## ADDENDUM 02 SOFTBALL UPGRADES

Date: Wednesday, December 3, 2025

Project #: 0323.25.002

Project Name: Softball Upgrades  
Vicksburg High School – 3701 Drummond St., Vicksburg, MS 39180  
Warren Central High School – 1000 MS-27, Vicksburg, MS 39180

VERIFY SCALES  
BAR IS ONE INCH ON ORIGINAL DRAWING  
1" = 1'  
IF NOT ONE INCH ON THIS SHEET, ADJUST  
SCALES ACCORDINGLY

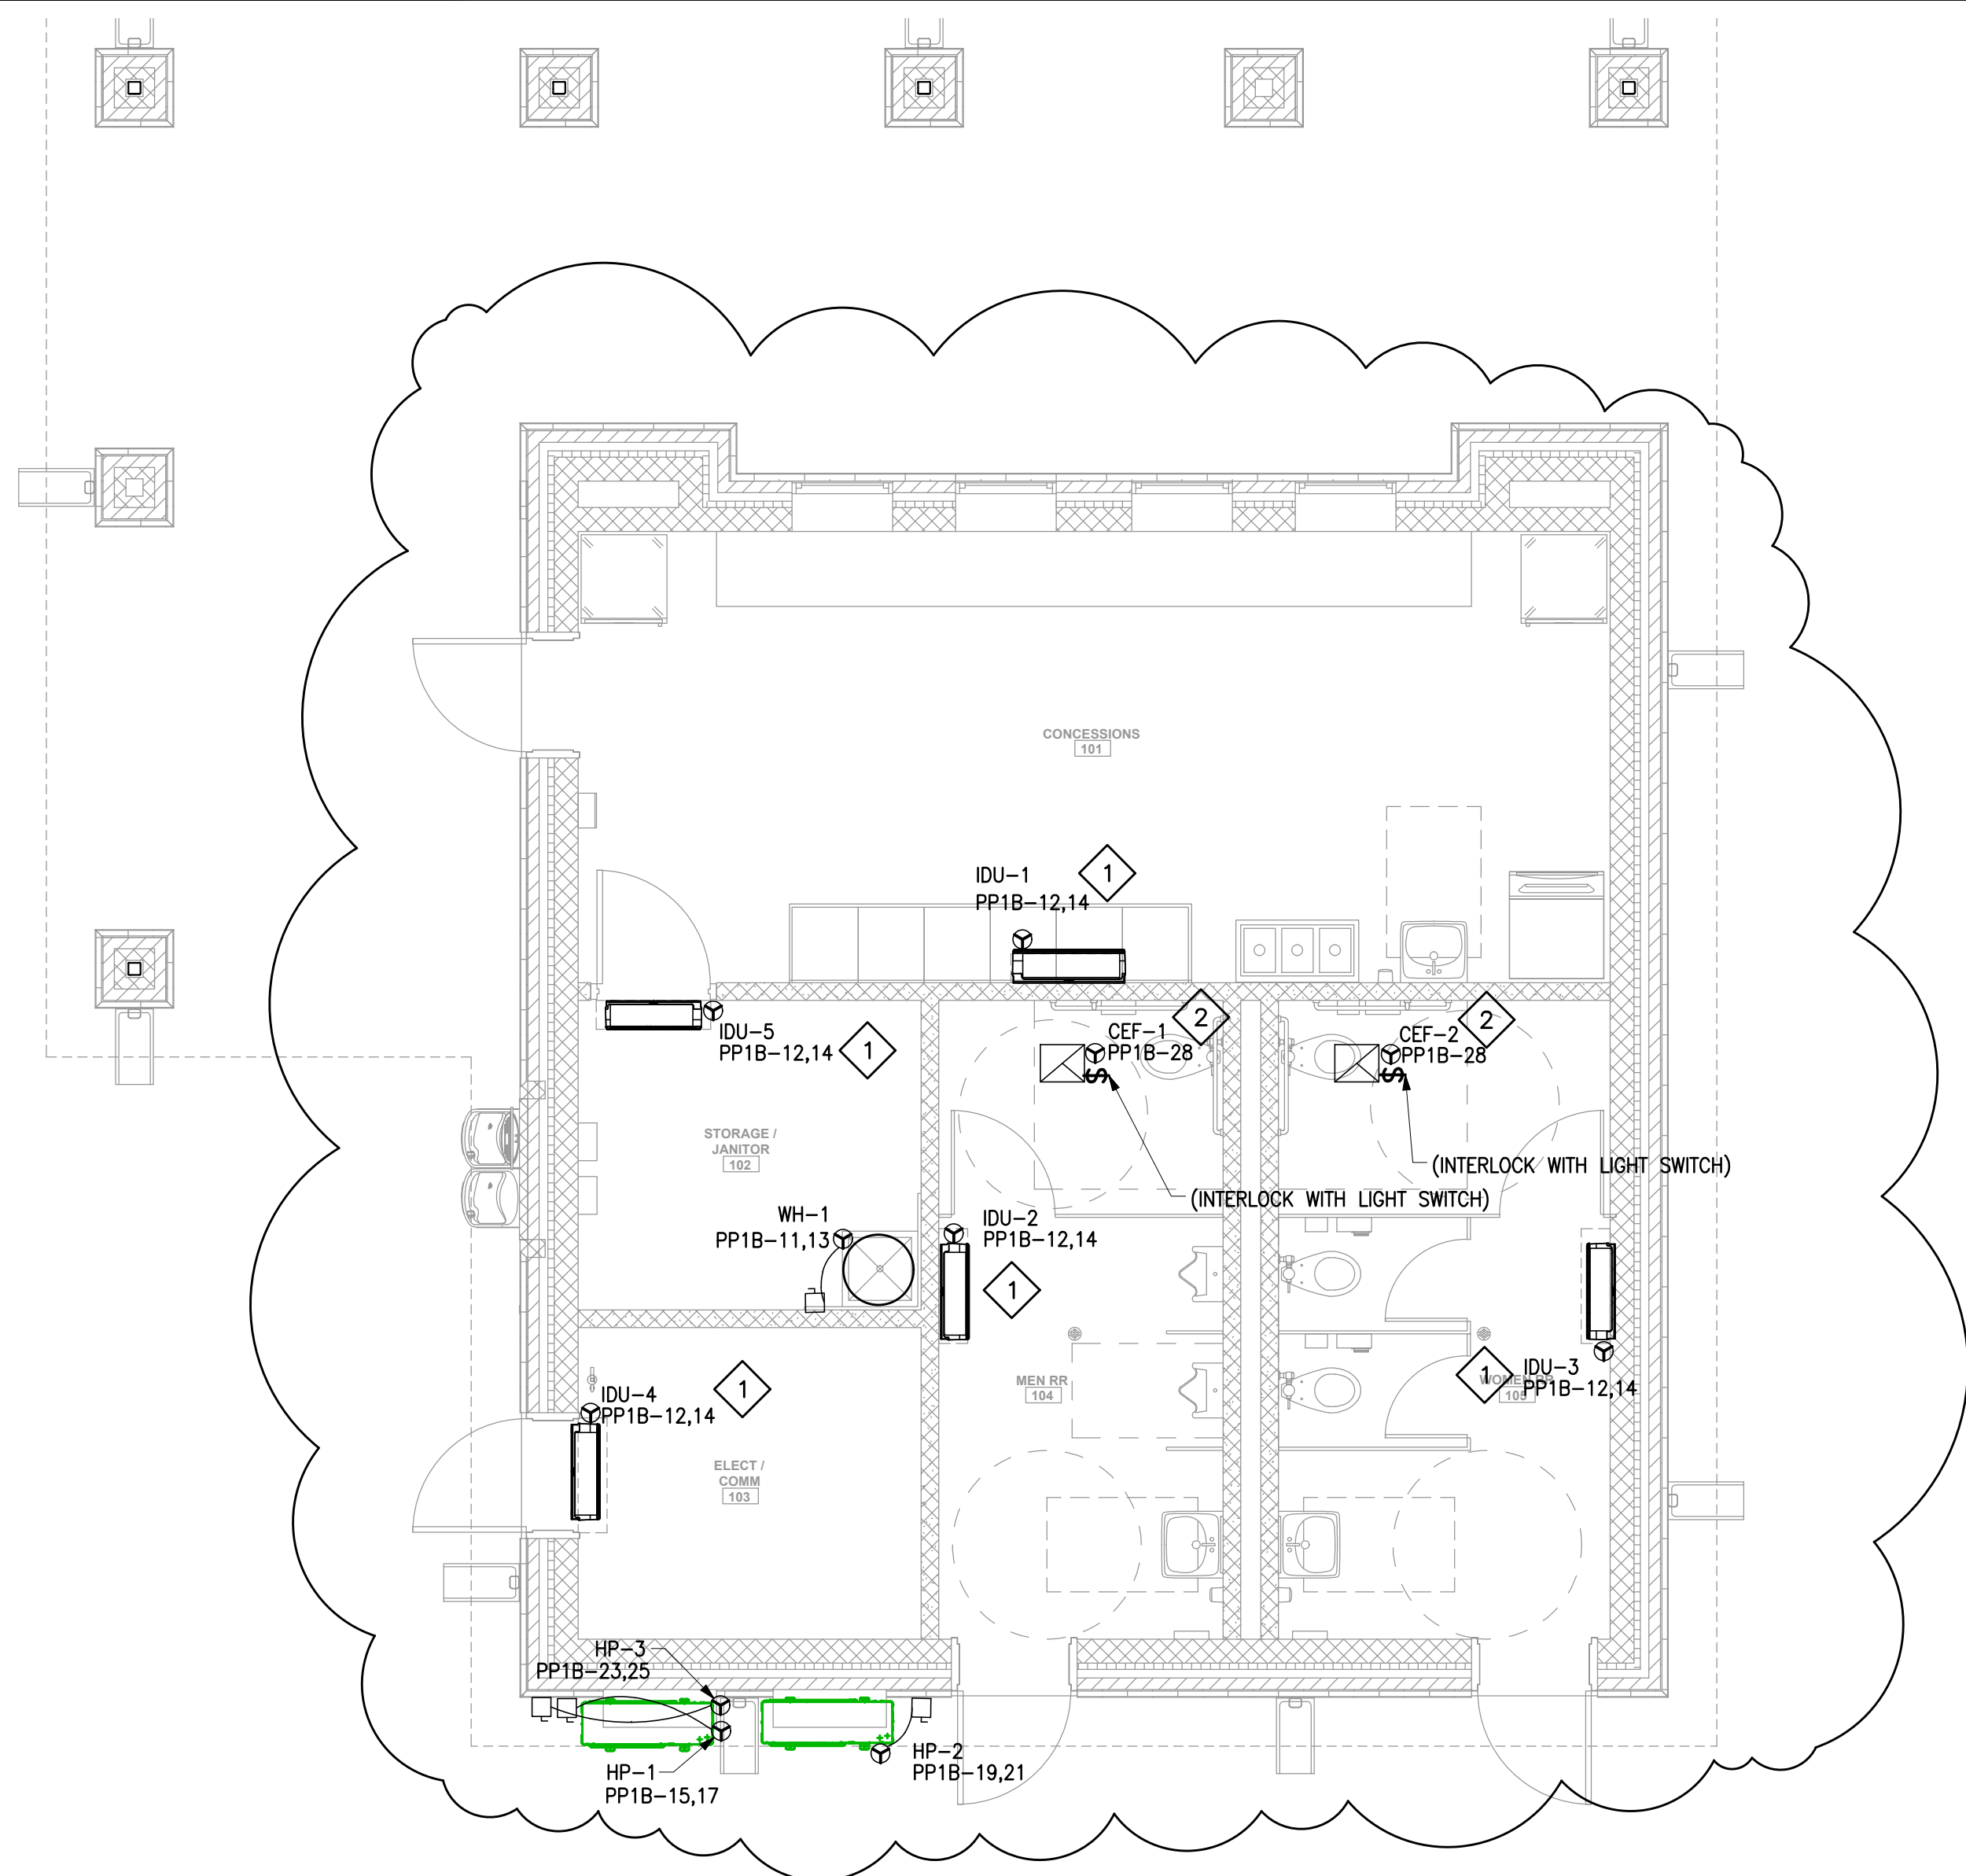
- B2. E141 Note 3 mentions fire alarm components & fire alarm contractor, are there fire alarm systems in the concession stands? **Note 3 on sheet E141 removed under this addendum.**
